**ADDENDUM NO. 2**

**For: Elementary School # 38  
522 Brookewater Boulevard  
Rosenberg, TX 77471  
for  
LAMAR CISD  
3911 Avenue I  
Rosenberg, TX 77471**

**ADDENDUM DATE: January 10, 2025**

**PROJECT NO: 24-028**

100% CONSTRUCTION DOCUMENTS  
**A10.01C**  
LEVEL 01 CEILING PLAN  
AREA C

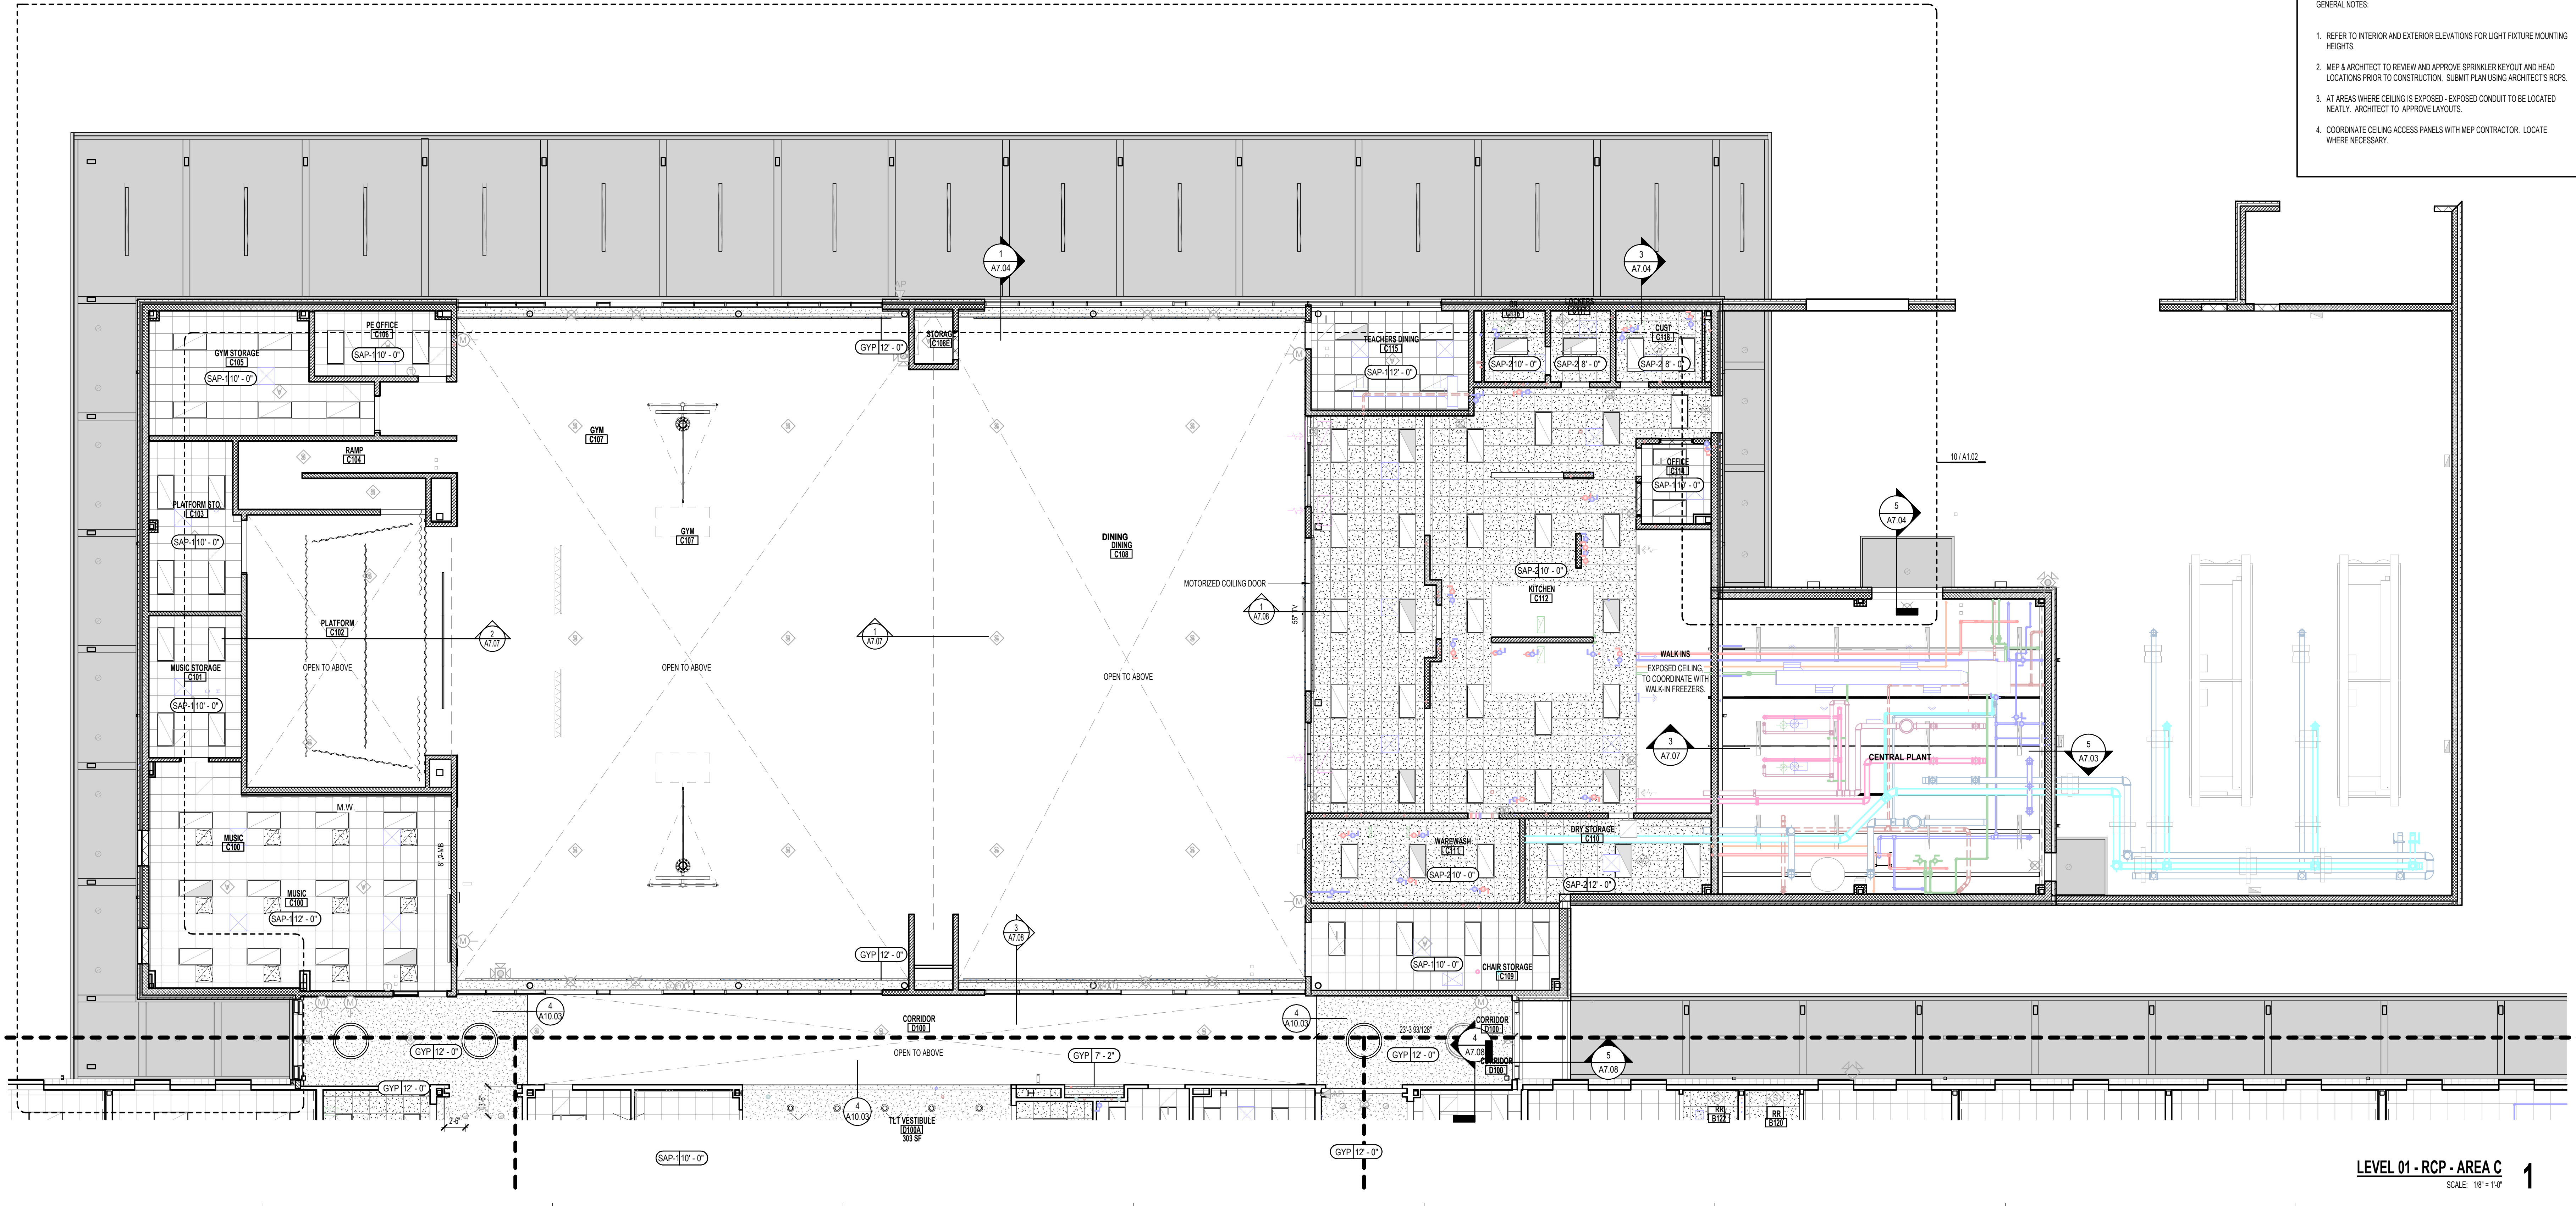
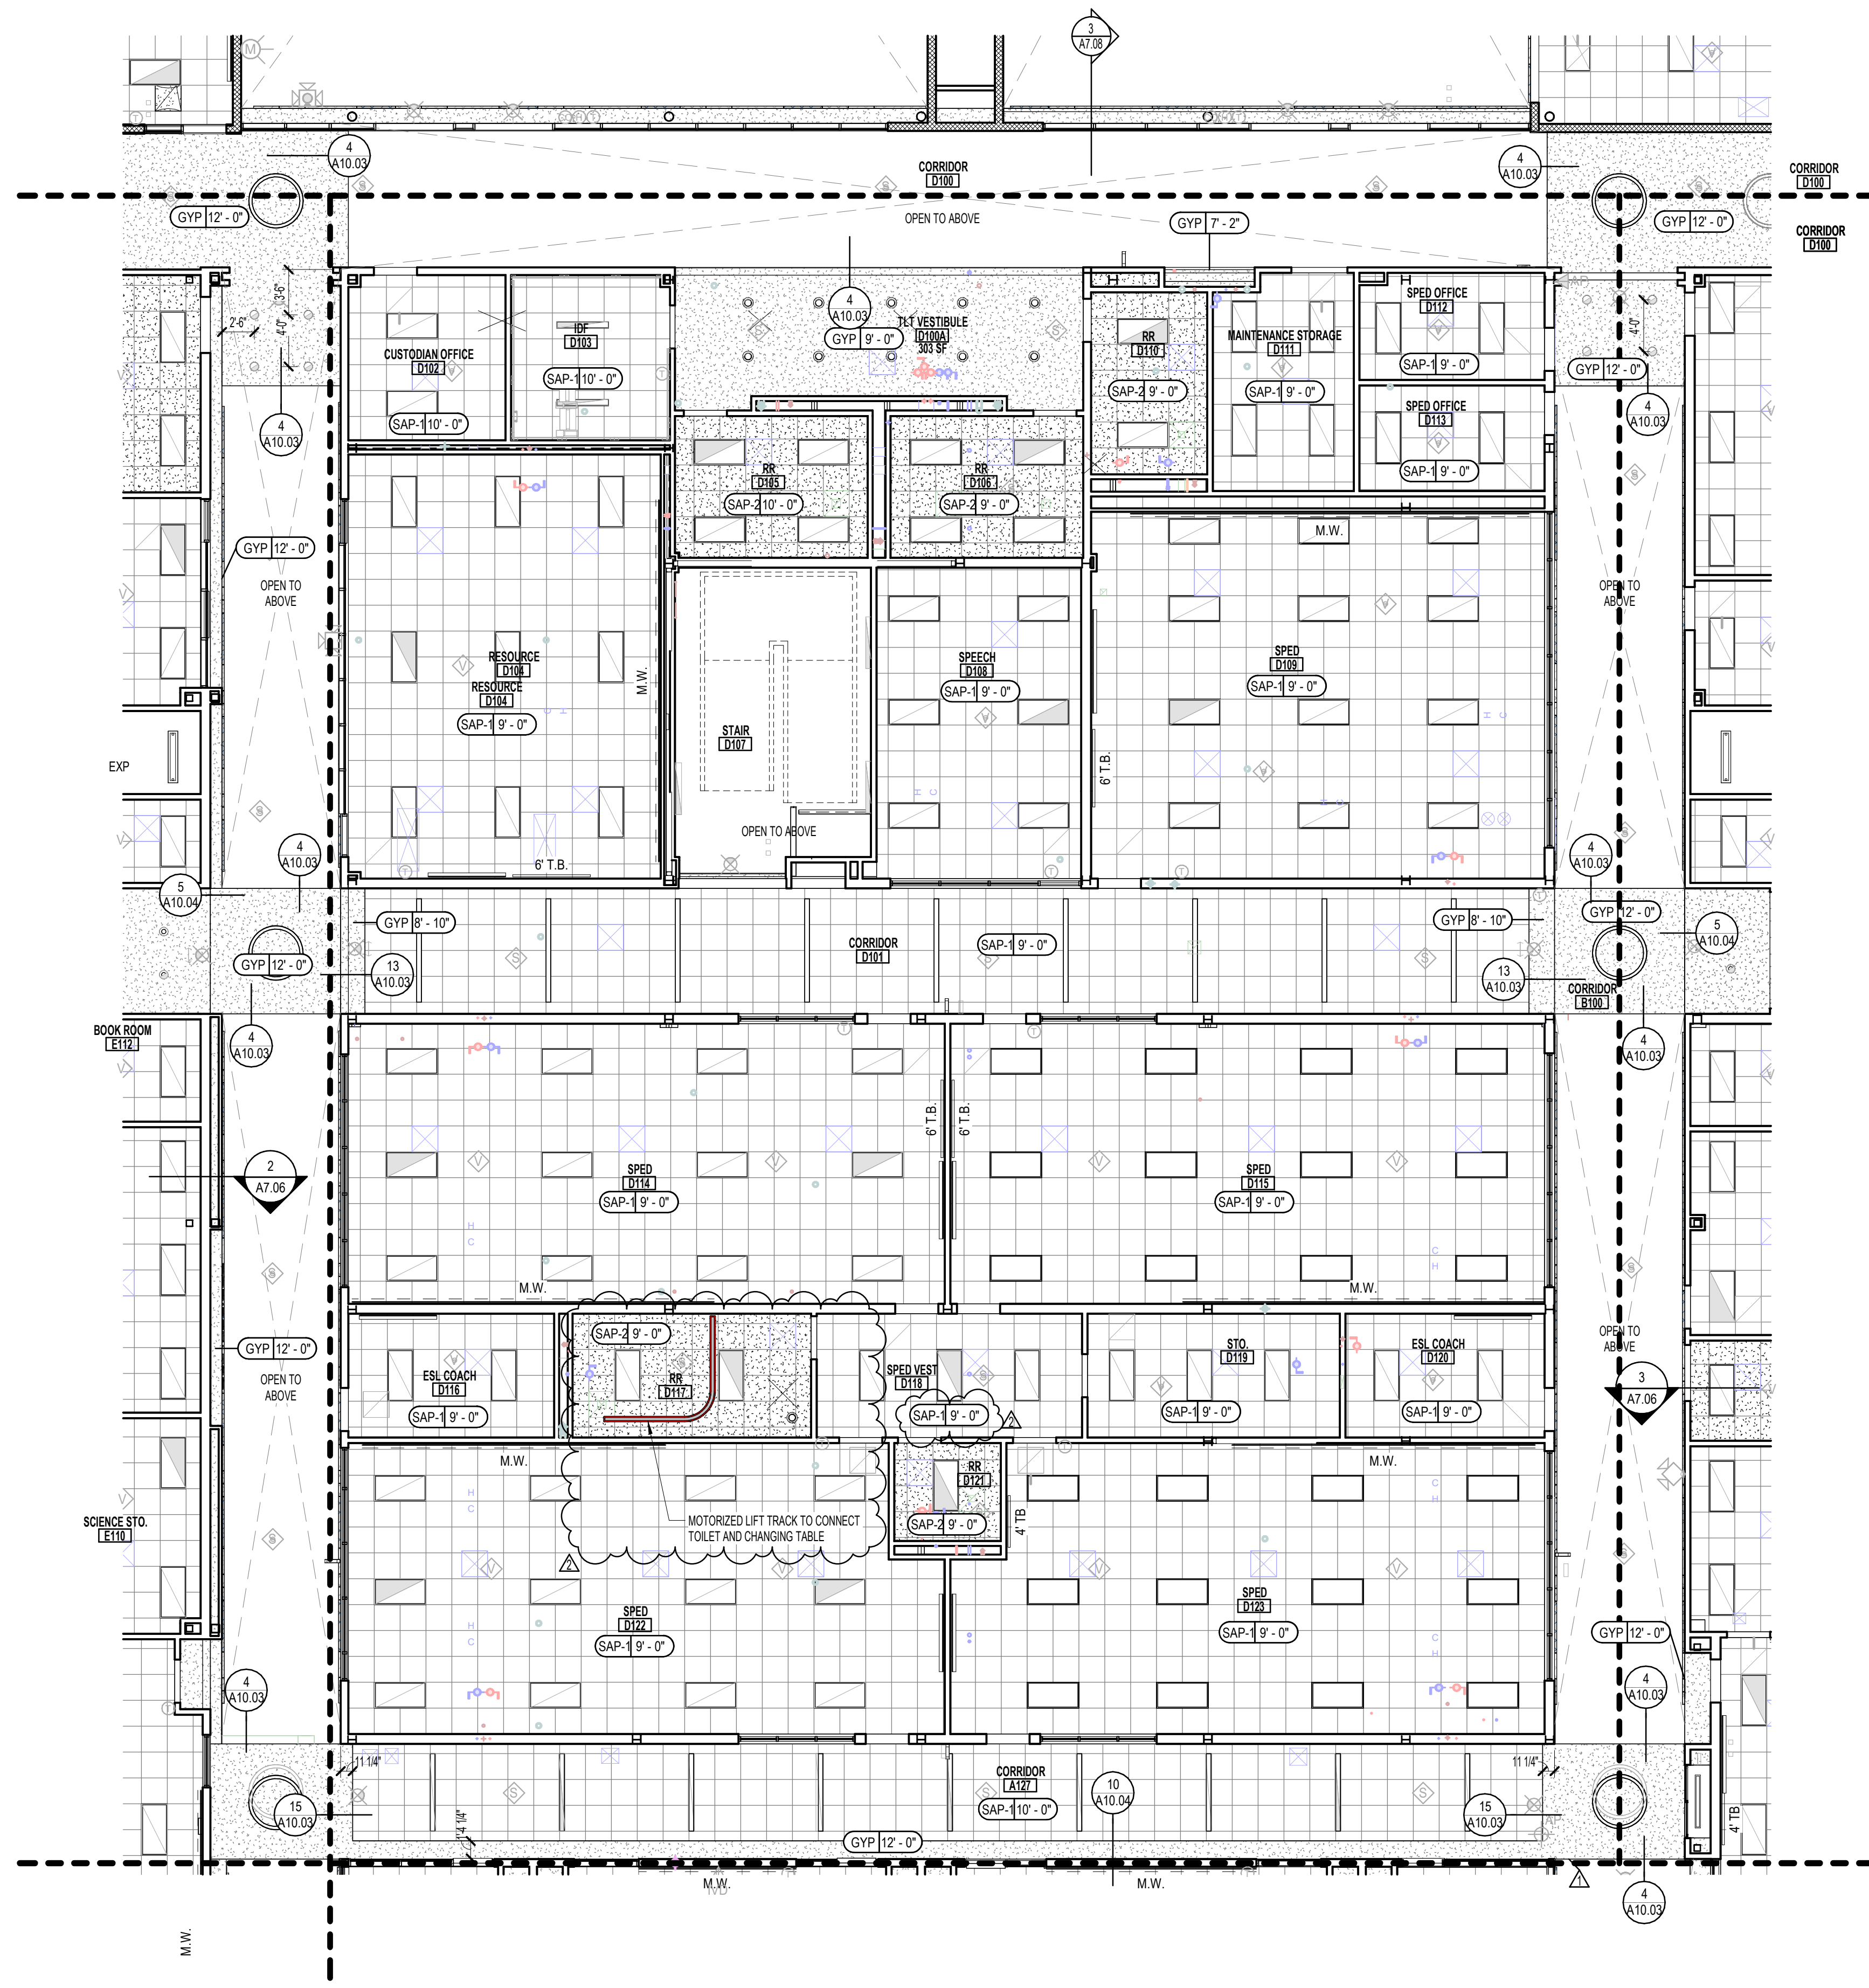
D2-64	A9.01A	Removed and added new wall clocks. Tagged Metal Shelving in A133 and A134.
D2-65	A9.01B	Removed and added new wall clocks. Removed metal shelving that was overlapping in room B106.
D2-66	A9.01C	Removed and added new wall clocks.
D2-67	A9.01D	Removed and added new wall clocks.
D2-68	A9.01E	Removed and added new wall clocks.
D2-69	A9.01F	Removed and added new wall clocks.
D2-70	A9.12	Made interior coiling door visible on elevation 4
D2-71	A10.01C	Added note regarding paint above cloud ceiling.
D2-72	A10.01D	Updated ceiling type for D118
D2-73	A10.01D	Motorized lift track path modified in RR D117

100% CONSTRUCTION DOCUMENTS  
**S2.05**  
 FOUNDATION PLAN - AREA E

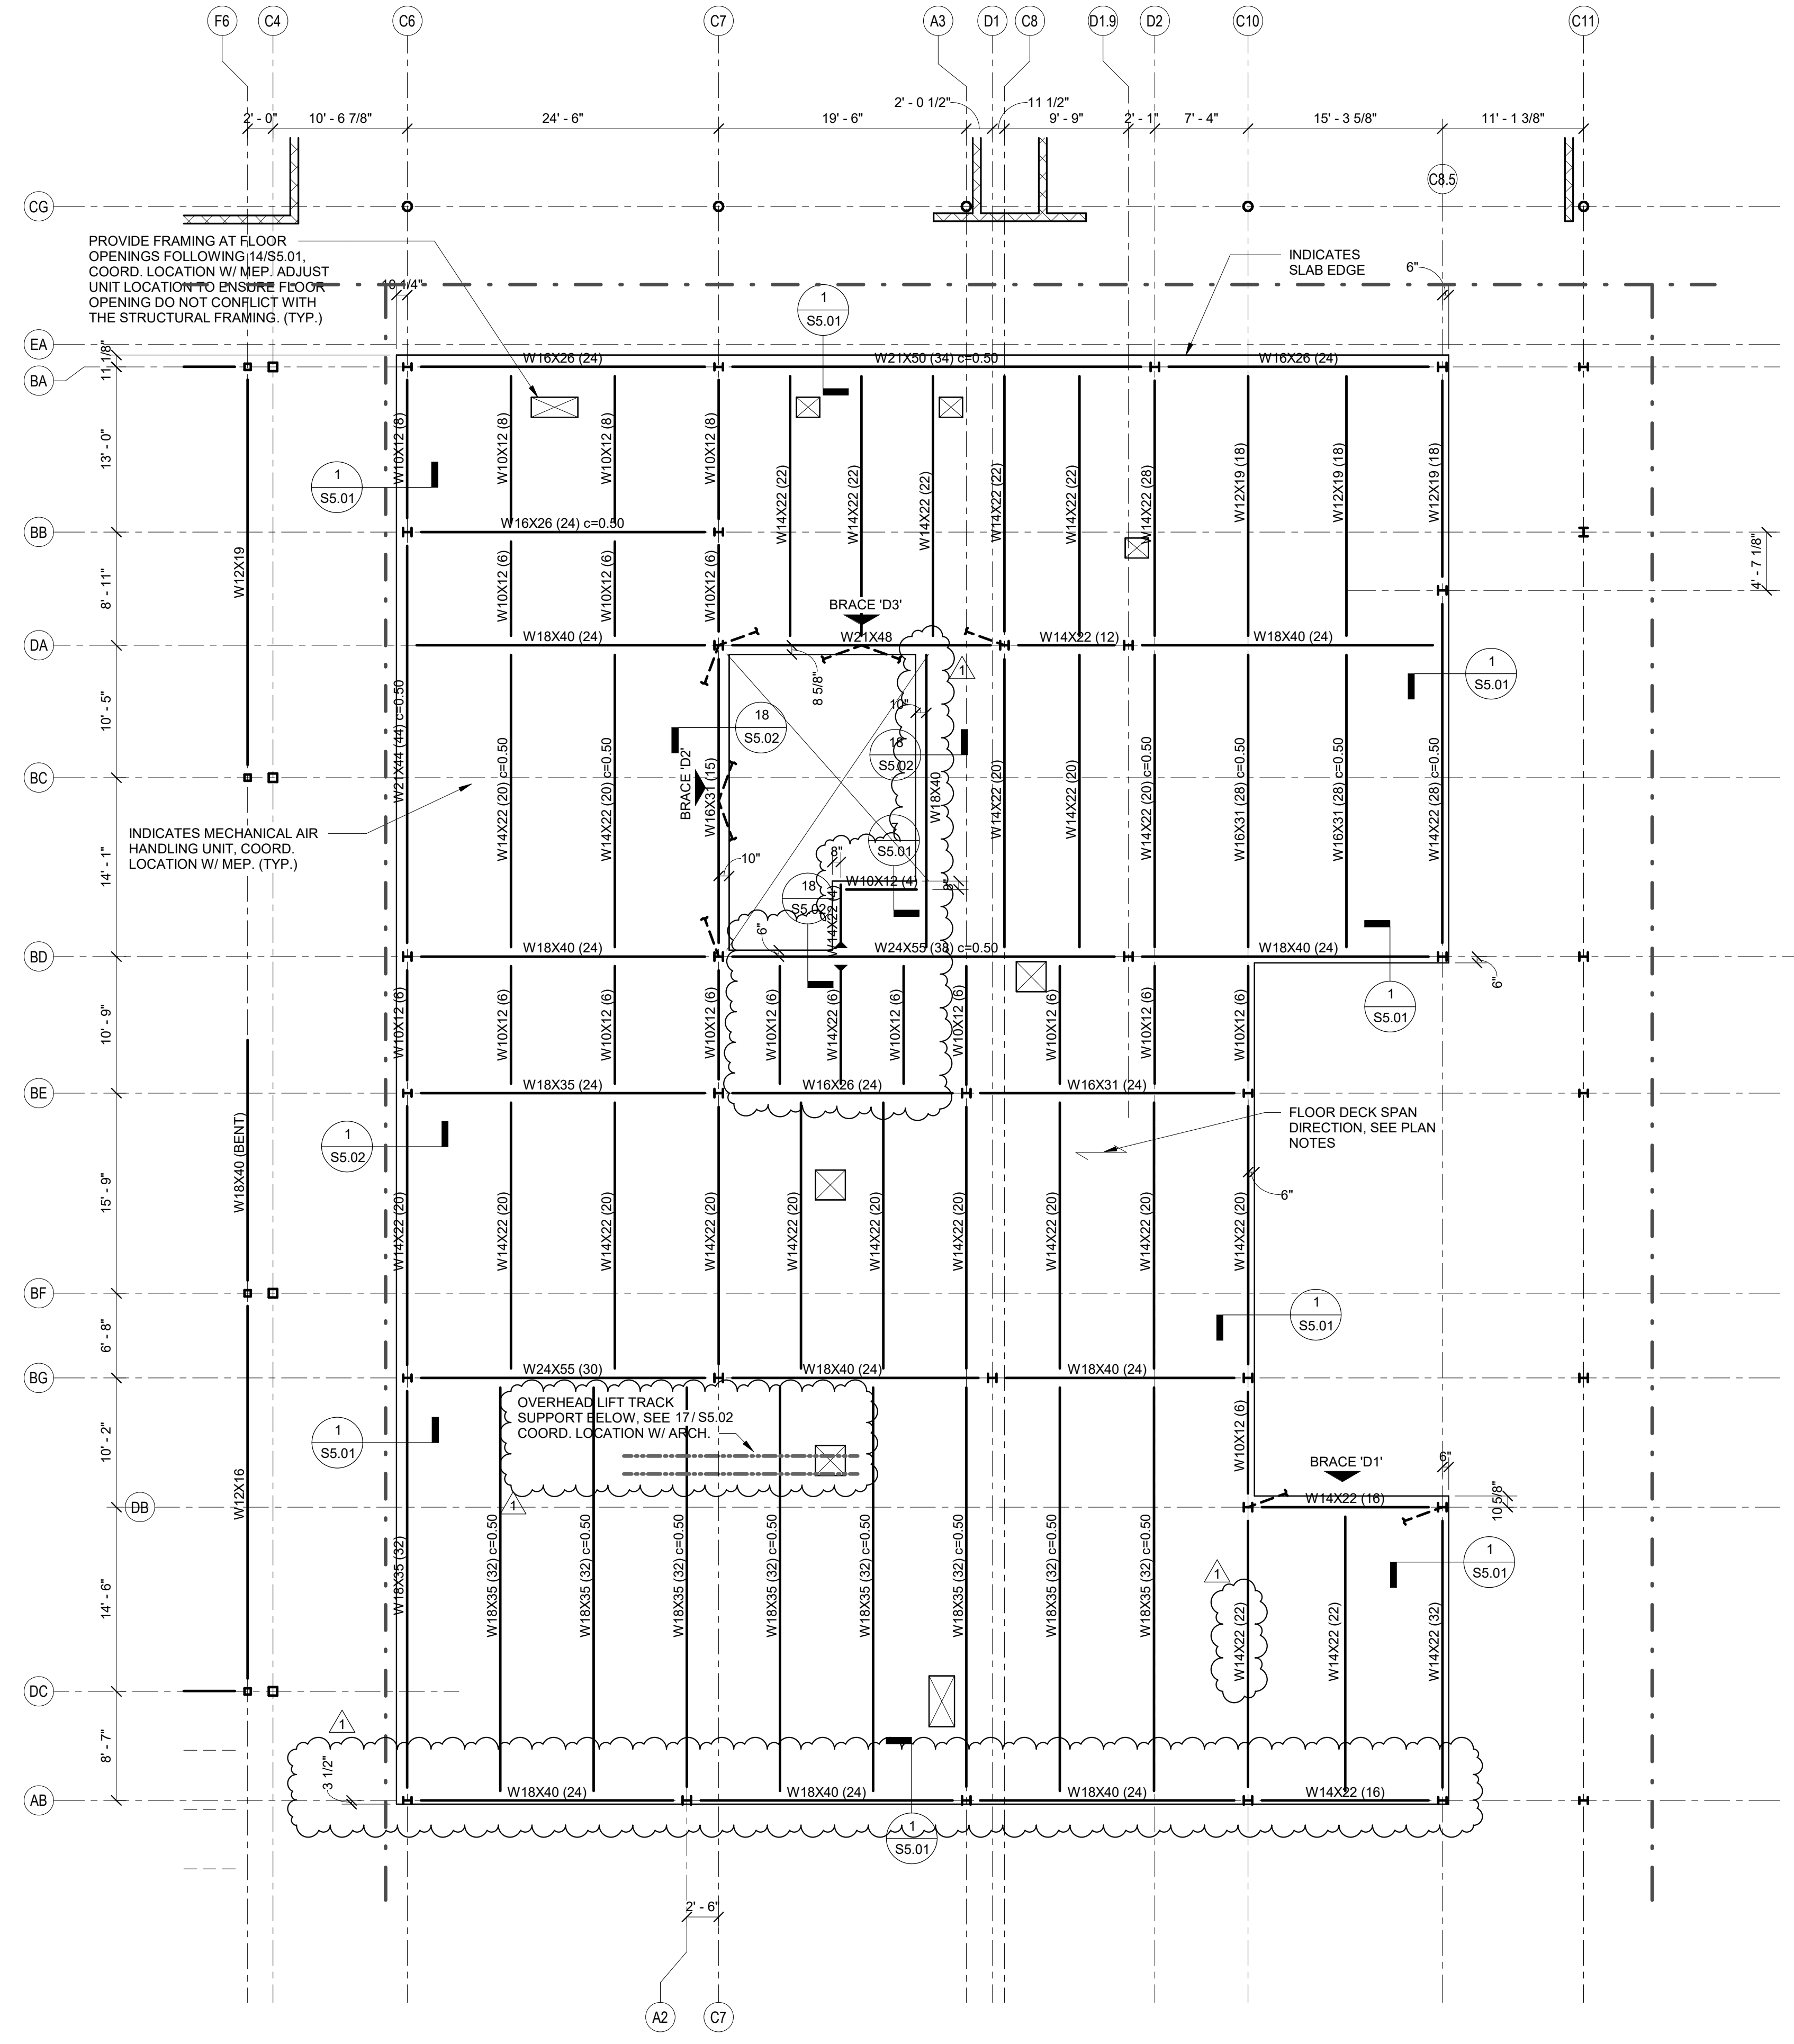
ITEM	SHEET	#	DESCRIPTION
D1-1	S2.01		Section cuts are added on grade beams at various locations.
D1-2	S2.01		Slab type and the grade beam layout is revised between Grids AD & AQ along the Grid C6 to match with the architectural finishes.
D1-3	S2.01		Grade beam at Grid AG.1 / A6 is shifted to align with the slab edge.
D1-4	S2.01		Missing pier tags are added at two locations.
D1-5	S2.01		Dimension is added to the pier just plan West of Grid A7.
D1-6	S2.02		Slab type and the grade beam layout is revised between Grids BD & BE to match with the architectural finishes.
D1-7	S2.03		Missing pier tags are added at two locations.
D1-8	S2.03		New piers are added at the grade beam under the cooler/freezer.
D1-9	S2.03		Grade beams are extended and new pier is added at the central plant entrance to match 13/S3.04.
D1-10	S2.04		Recessed slab at the shower and the related notes on the plan is removed.
D1-11	S2.05		Missing pier tags is added at Grid E14.
